Item ID: D206-667-207BL Accept ***N900040100*** Setup Start ***NS1***
 Revision ID: Stop ***NS2***
 Item Name: Aft Crosstube - Mid Height 206L / L1 / L3 / L4, Blue
 Start Date: 10/28/2015 Start Qty: 1.00 ***1*** Cust Item ID:
 Required Date: 10/28/2015 Req'd Qty: 1.00 ***1*** Customer:
 Reference:

DART AEROSPACE LTD		Work Order: 138480
Description: Crosstube Mid Aft (206L)		Part Number: D206-667-207
Inspection Dwg: D206-667-247 Rev: A		Page 1 of 1

DART AEROSPACE LTD HAWKESBURY, ONTARIO, CANADA	
DRAWING NO. D206-667-247	REV. A
TITLE CROSSTUBE ASS'Y (206L MID AFT)	SCALE NTS

DRAWING NO. D206-667-247	TITLE CROSSTUBE ASS'Y (206L MID AFT)	REV. A	DART AEROSPACE LTD ENGINEERING ORDER		D.E.O. NO. D206-667-247-A-1	SHEET NO. SHEET 1 OF 1	SCALE NTS
DRAWN <i>gp</i>	CHECKED <i>ASS</i>	MFG. APPR. <i>KD</i>	APPROVED <i>JMP</i>		DE APPR. <i>#</i>		
DATE 11.07.15	DATE 11.07.20	DATE 11.07.21	DATE 11/07/21		DATE 11.07.21

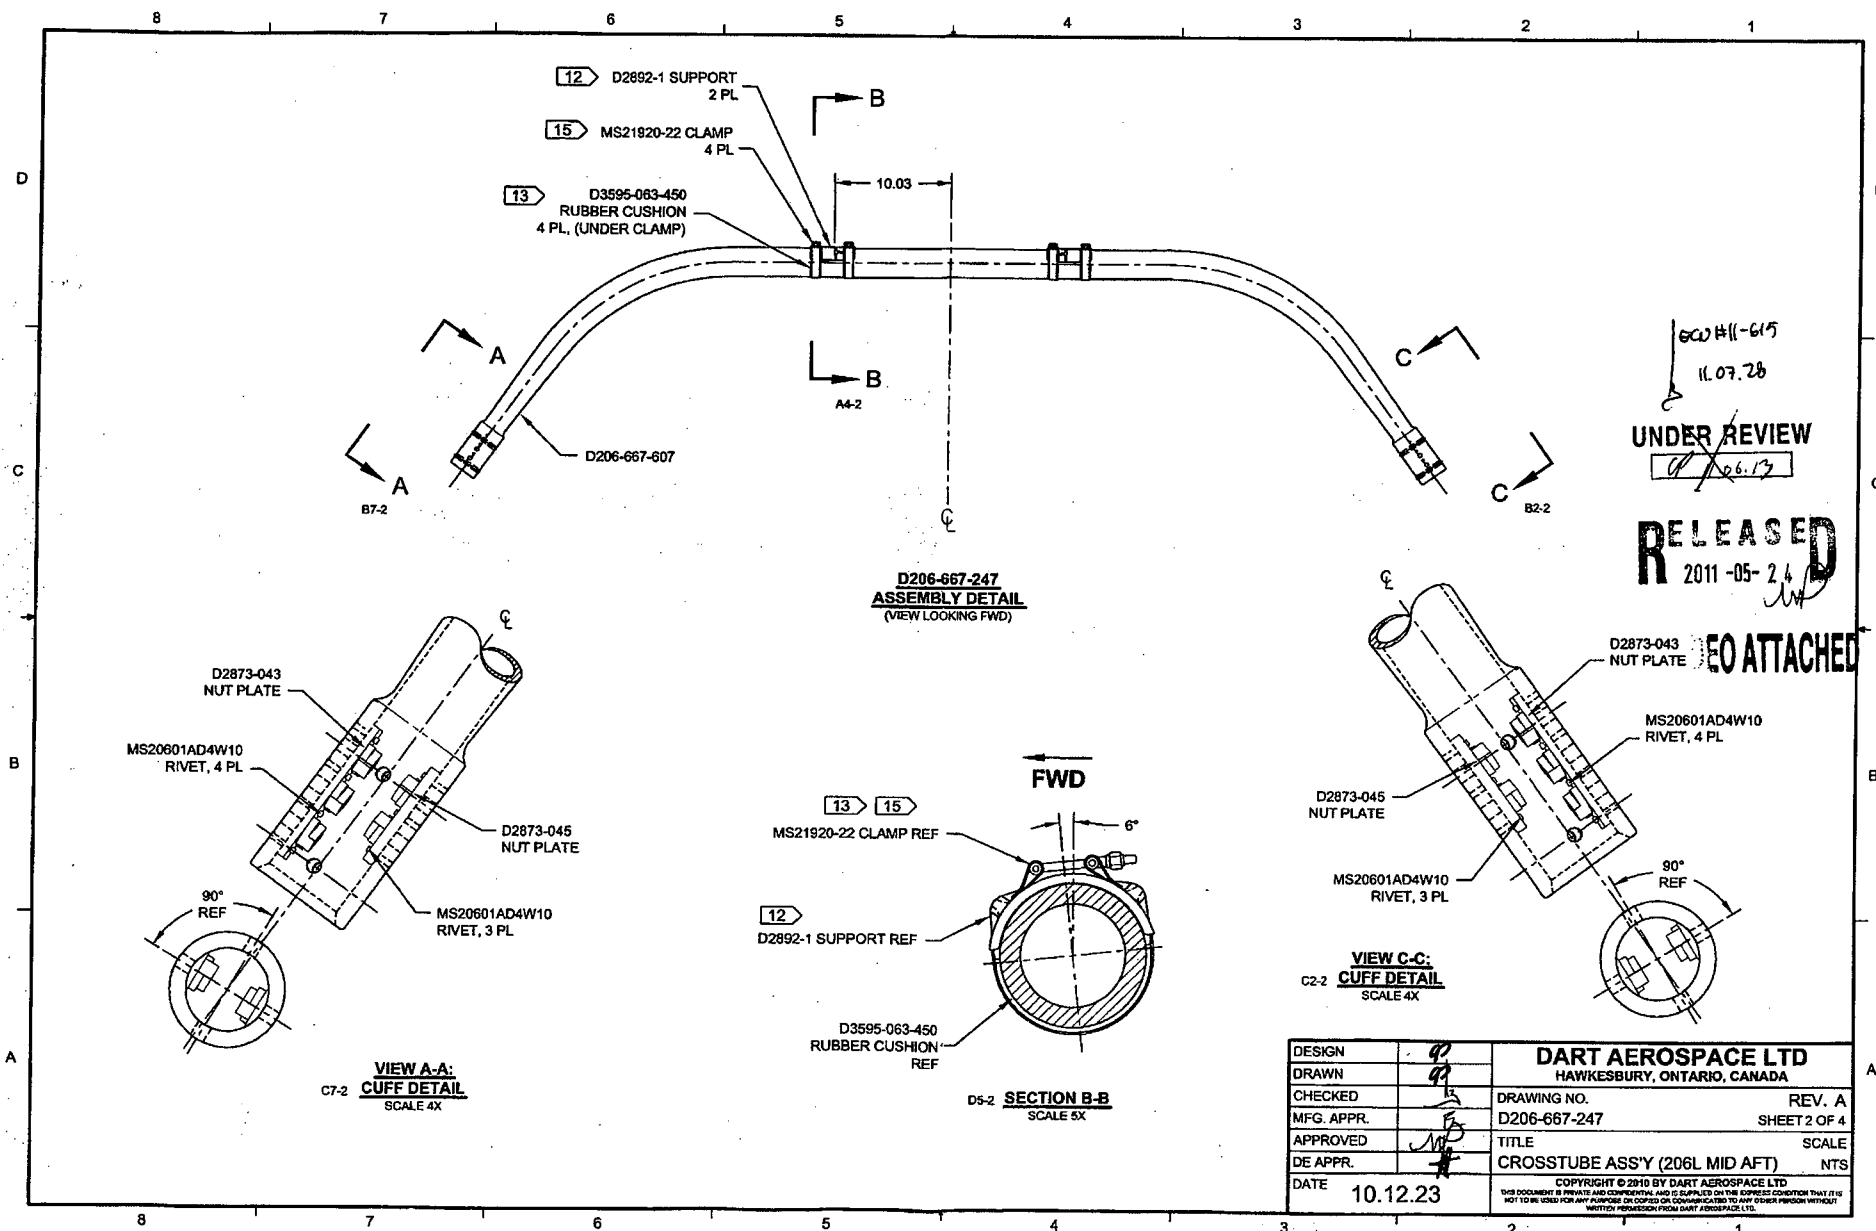
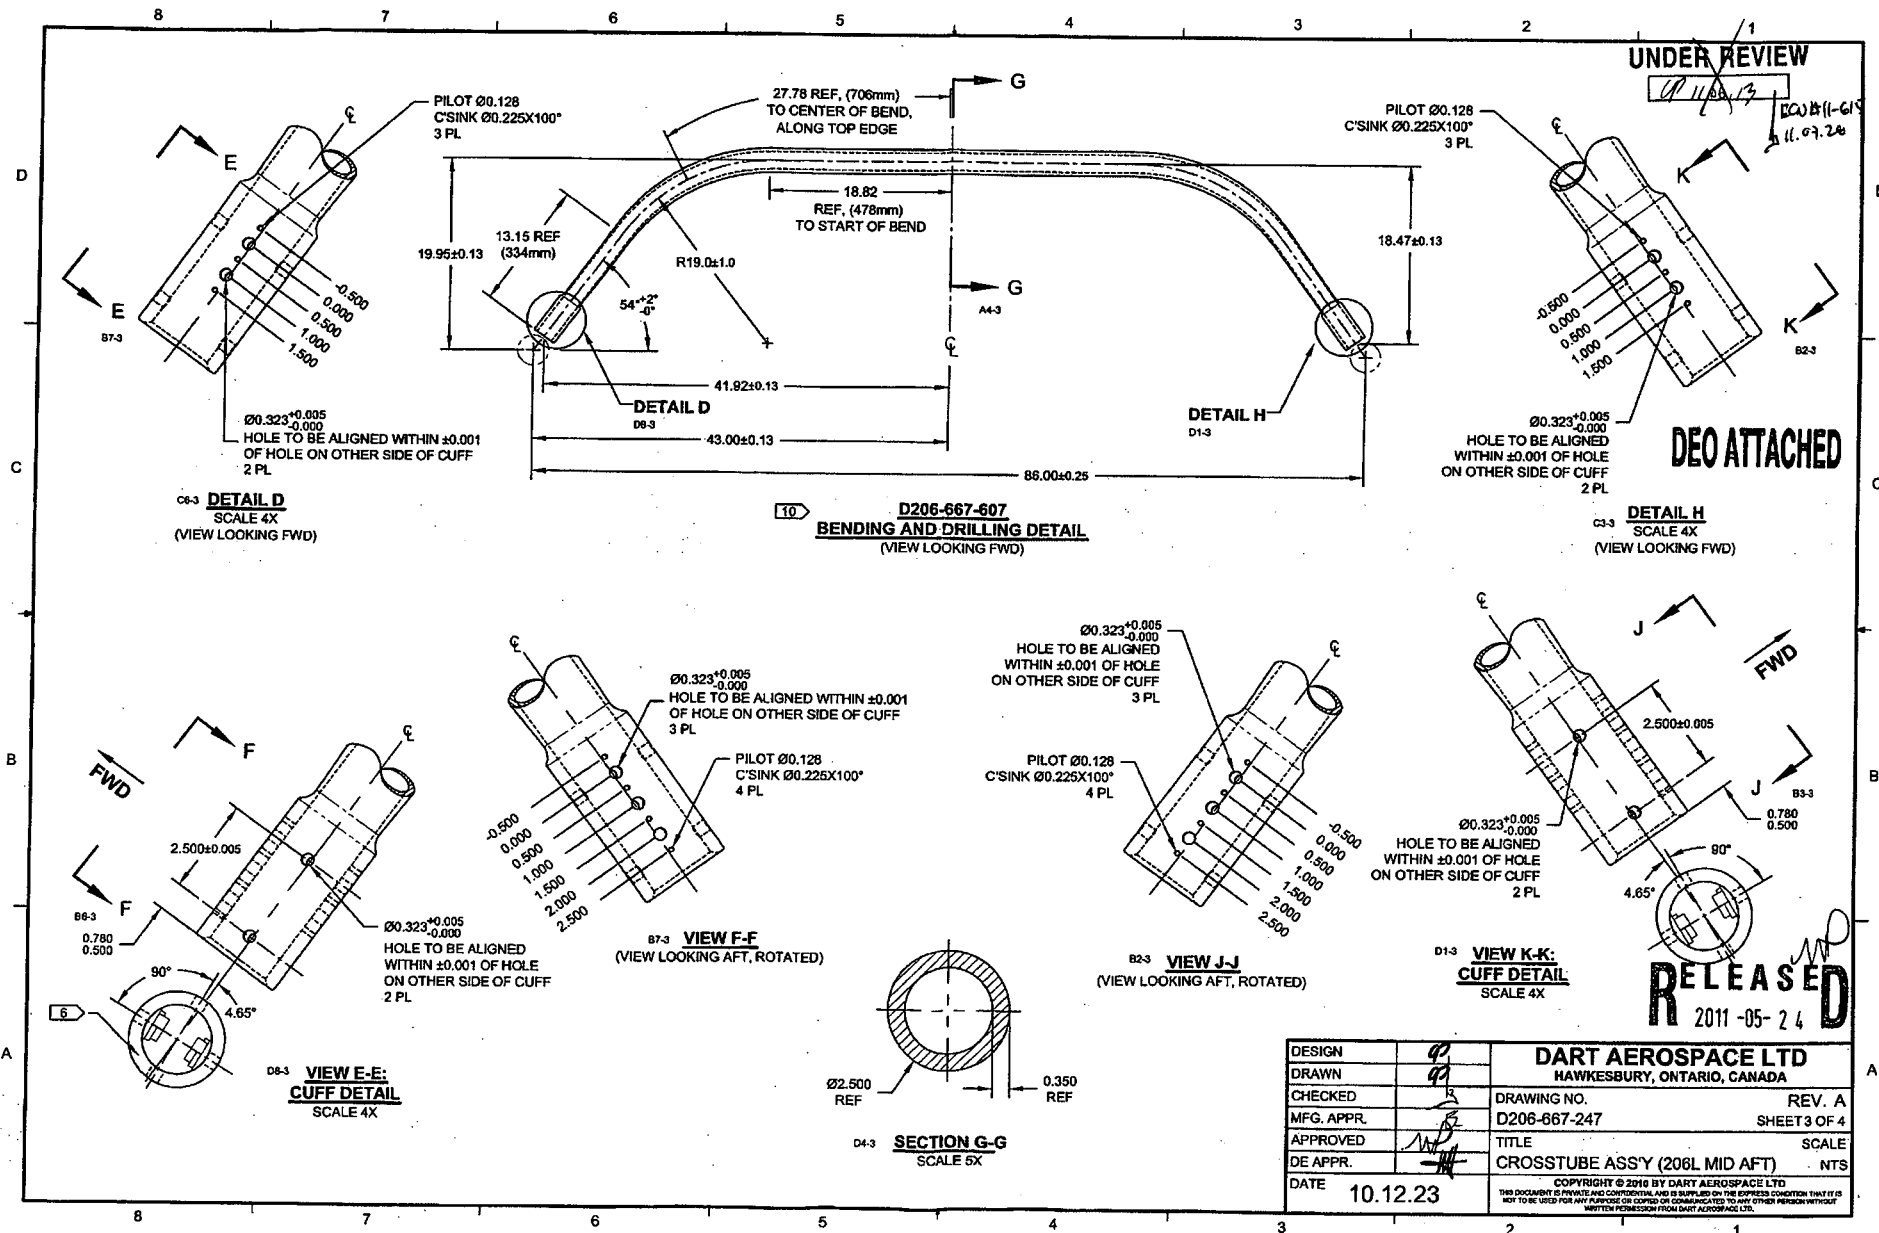
PURPOSE:

REPLACE MAGNOBOND WITH PROSEAL.

NOTE 12 & 15, SHEET 1 IS AMENDED AS FOLLOWS:

IS:

Item	Qty -247	Part Number	Description
9	A/R	PROSEAL 890 B-2	SEALANT, AMS-S-8802 CLASS B-2

- 12) TO INSTALL D2892-1 SUPPORT: ABRASE MATING SURFACE OF SUPPORT AND CROSSTUBE WITH 180-GRIT SANDPAPER AND REMOVE RESIDUE WITH MEK (OR EQUIVALENT). APPLY A 0.04" TO 0.07" THICK LAYER OF PROSEAL 890 CLASS B-2 (OR AMS-S-8802 CLASS B-2) SEALANT TO MATING SURFACE OF SUPPORT.
- 15) TORQUE CLAMPS 80 TO 100 IN-LB. ENSURE AT LEAST 1.5 THREADS SHOWING IN SAFETY AND THAT NUT HAS NOT BOTTOMED-OUT AFTER TORQUING. **PRIOR TO PACKAGING, RE-CHECK TORQUE ON CLAMPS AFTER PROSEAL 890 SEALANT HAS CURED FOR 72 HOURS.**
